**Town of Kittery
 Planning Board Meeting
 June 8th, 2023**

ITEM 4 – 23 Bond Road– Shoreland Development Plan Review

37 APPLICATION & PLAN REVIEW

SHORELAND DEVELOPMENT PLAN
OF LAND LOCATED AT
23 BOND ROAD
KITTELY, YORK COUNTY, MAINE

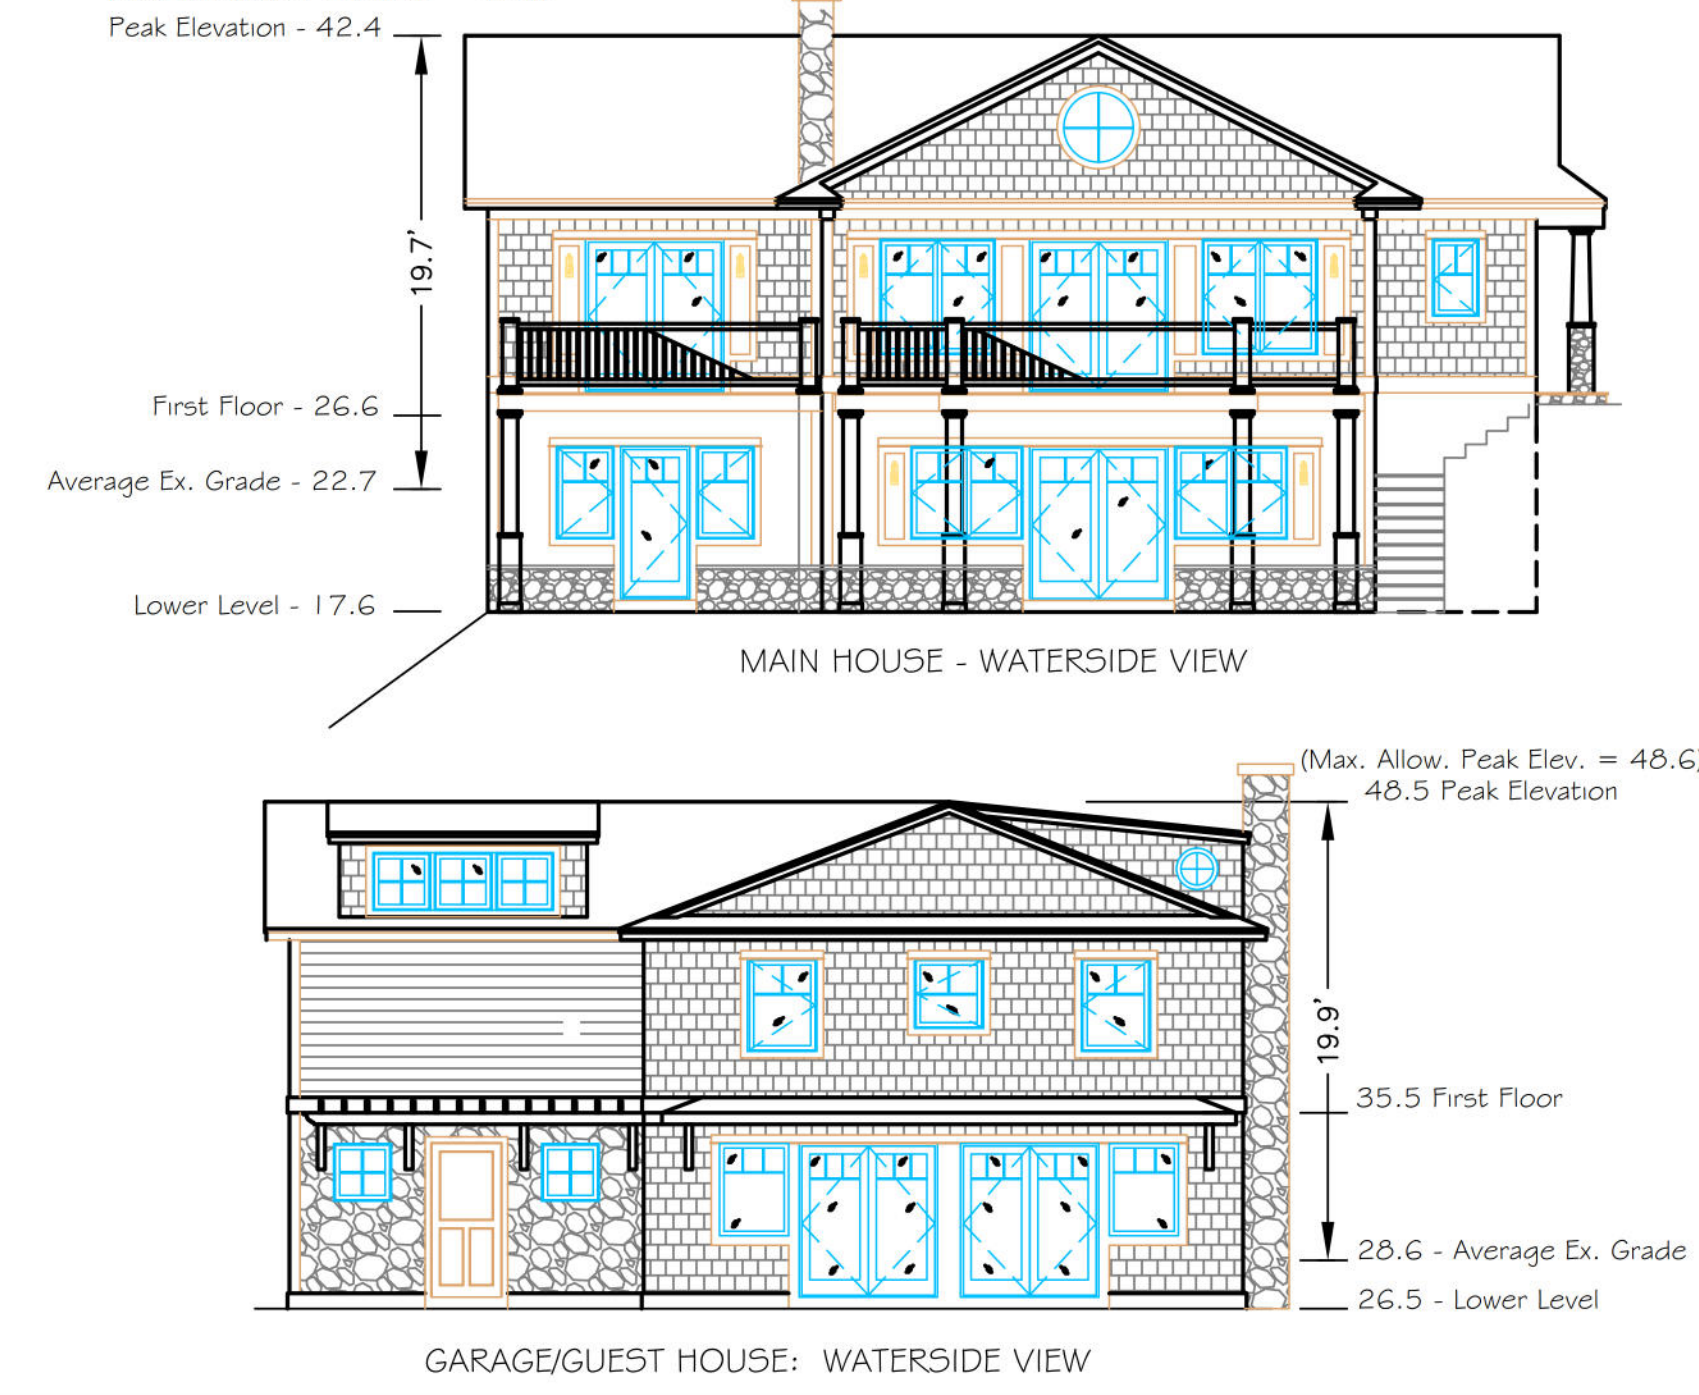
- 48 4. The use of aquastone pavers for a side driveway of two cars was proposed to meet de-vegetation
49 requirements. Aquastone pavers are a type of permeable surface that reduce total devegetated area
50 by allowing grass to grow within tiles. Staff reached out to Maine DEP, who stated that vegetation
51 credit is not awarded to aquastone pavers as the grass planted within the area is difficult to maintain
52 and often dies within a few years.

- 53 a. When notified of this, the applicant submitted a revised plan replacing the aquastone pavers
54 with paved tire strips and thicker strips of greenery in between them to meet devegetation
55 requirements. Though aquastone pavers are no longer included within this proposal, this
56 note is to remain as conformation that such permeable surfaces are not an allowable method
57 to reduce devegetation.

- 70 7. **§16.4.28.E.2** allows 20% of total lot area in the shoreland zoning overlay to be comprised of non-
71 vegetated surfaces or structures. With a lot size of 23,143 sq ft, current devegetation sits at 4,379
72 sq ft, or 18.9%. The plan proposes to increase coverage to 4,629 sq ft, which meets the maximum
73 20% allowable coverage of the lot.

DESCRIPTION: MODIFIED DRIVEWAY AND UPDATED ARCHITECTURAL DETAIL

LANDSCAPE CONCEPT PLAN

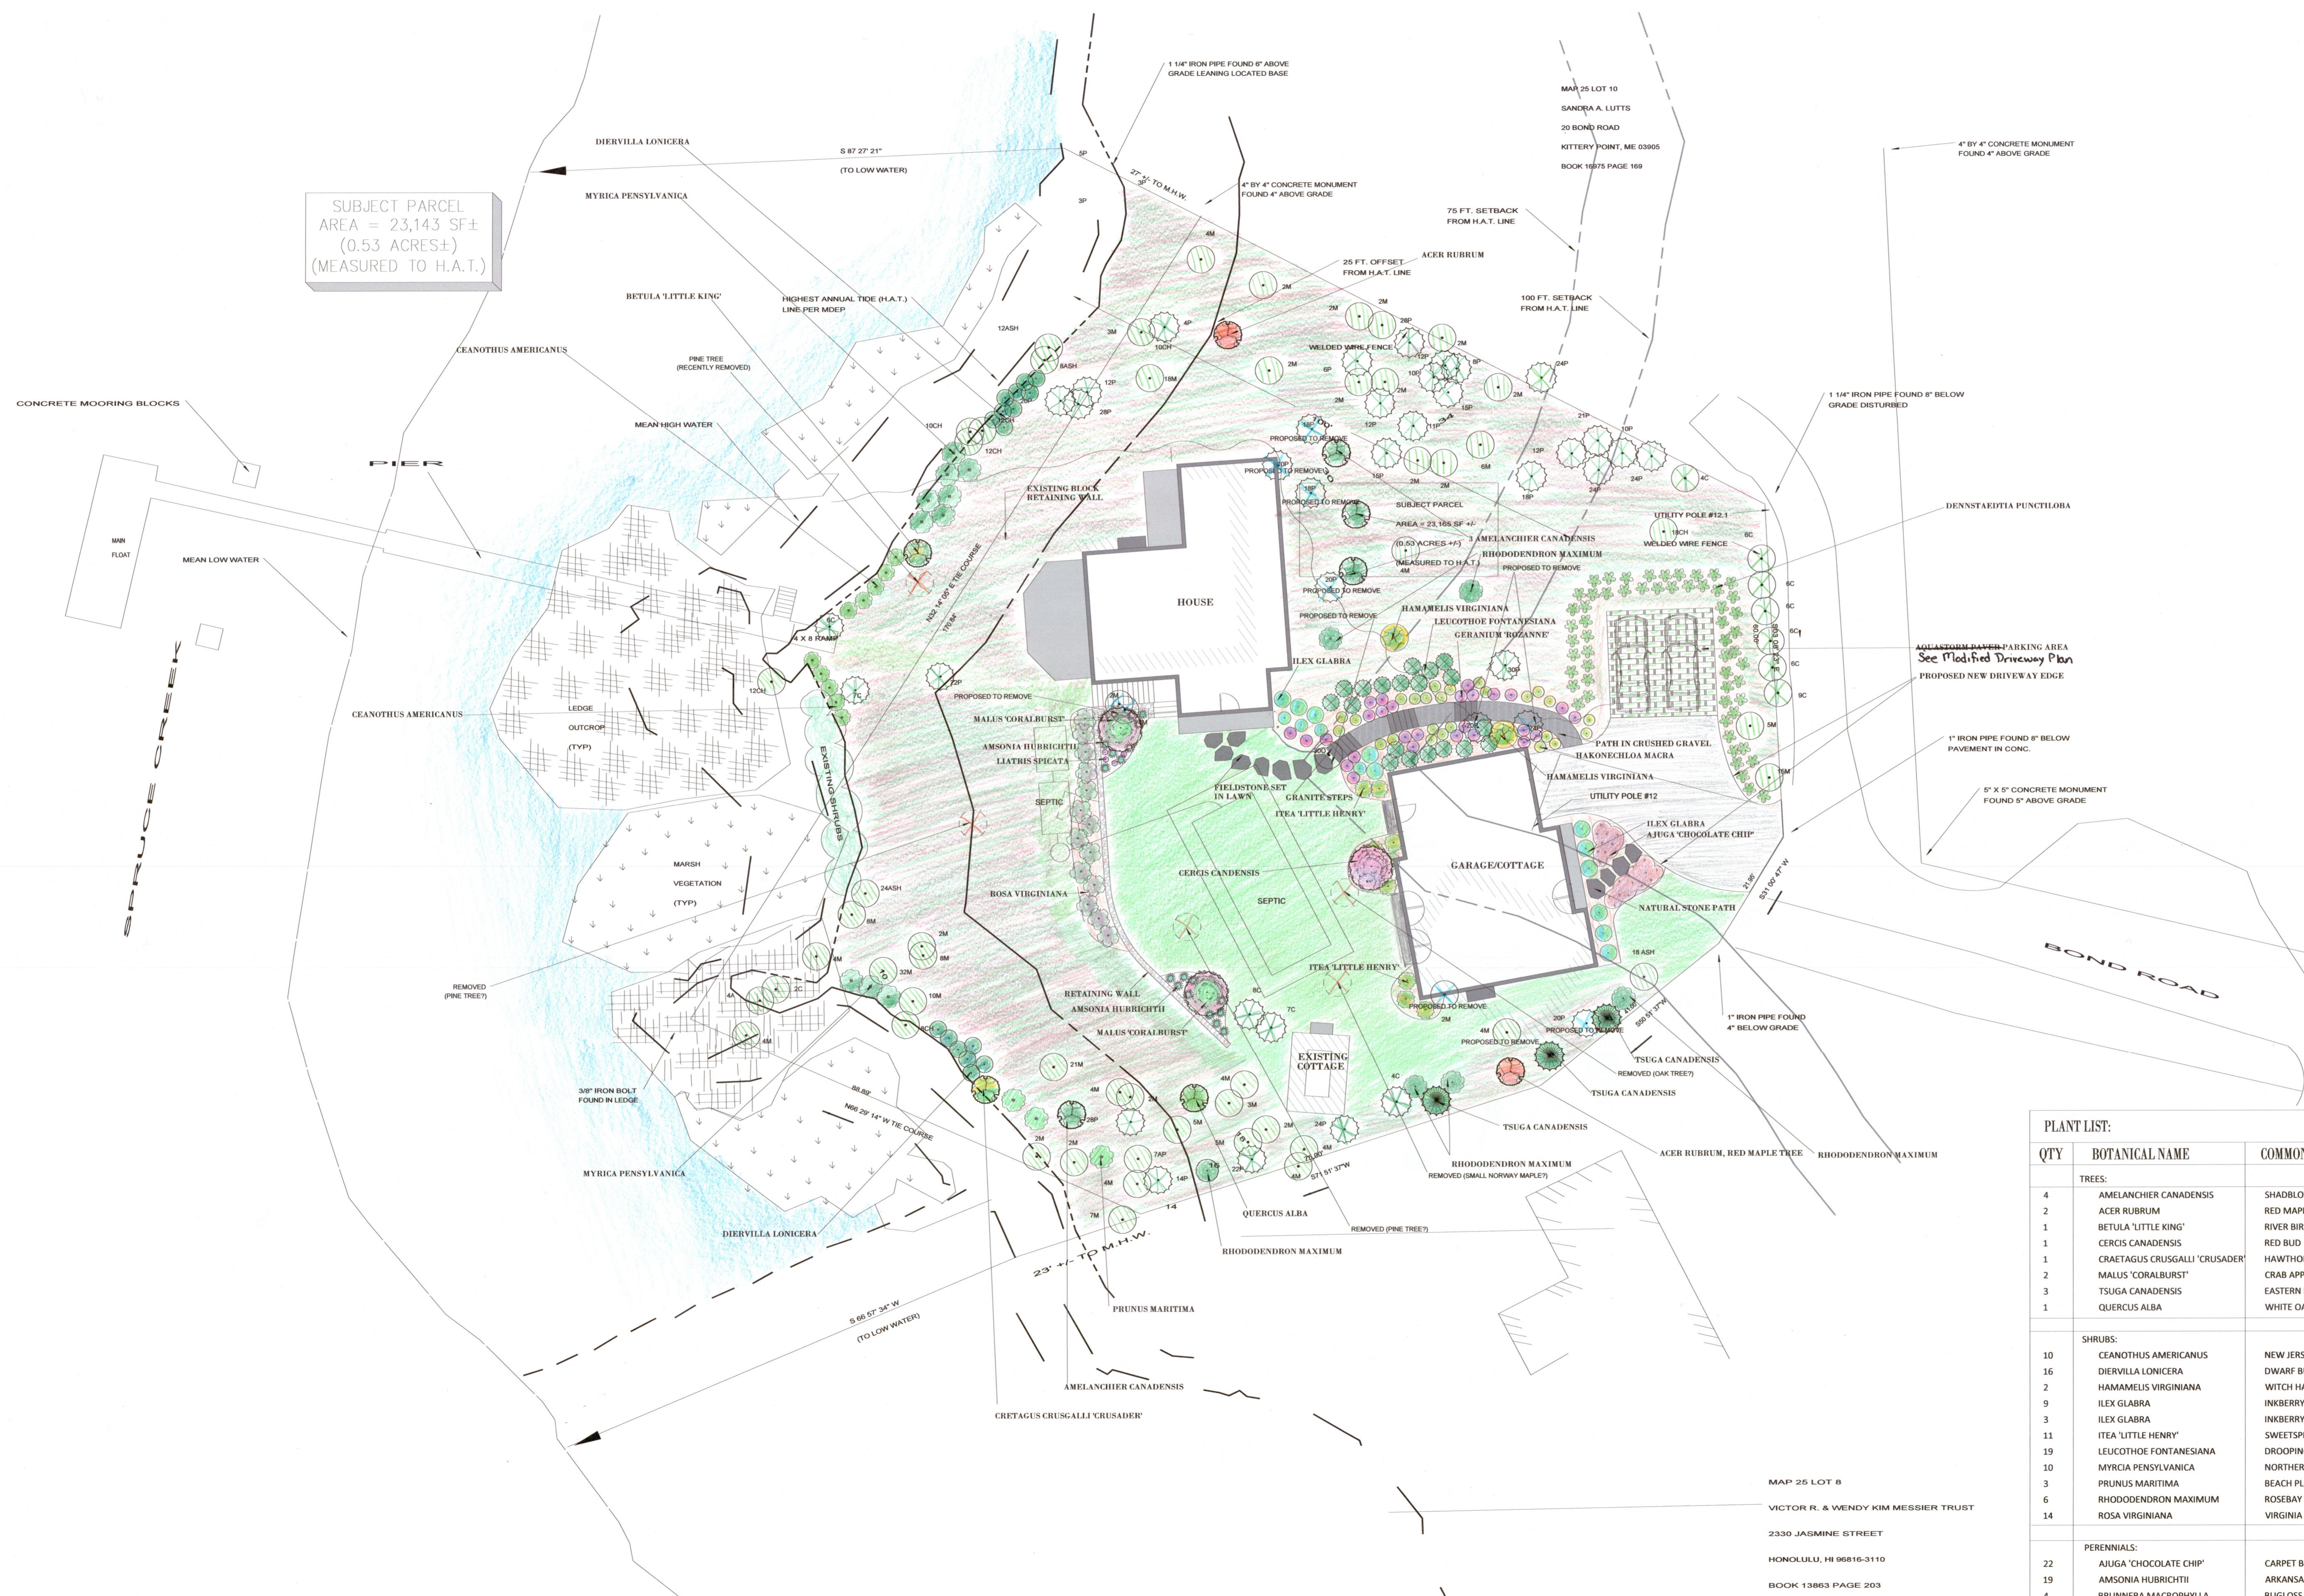
- 39 1. The shoreland revegetation plan is a combination of native shrubs and trees to be planted along
40 the shoreland and around the proposed home. The new vegetation will provide food and habitat
41 for wildlife, enhance aesthetics, and reduce the risk of erosion.
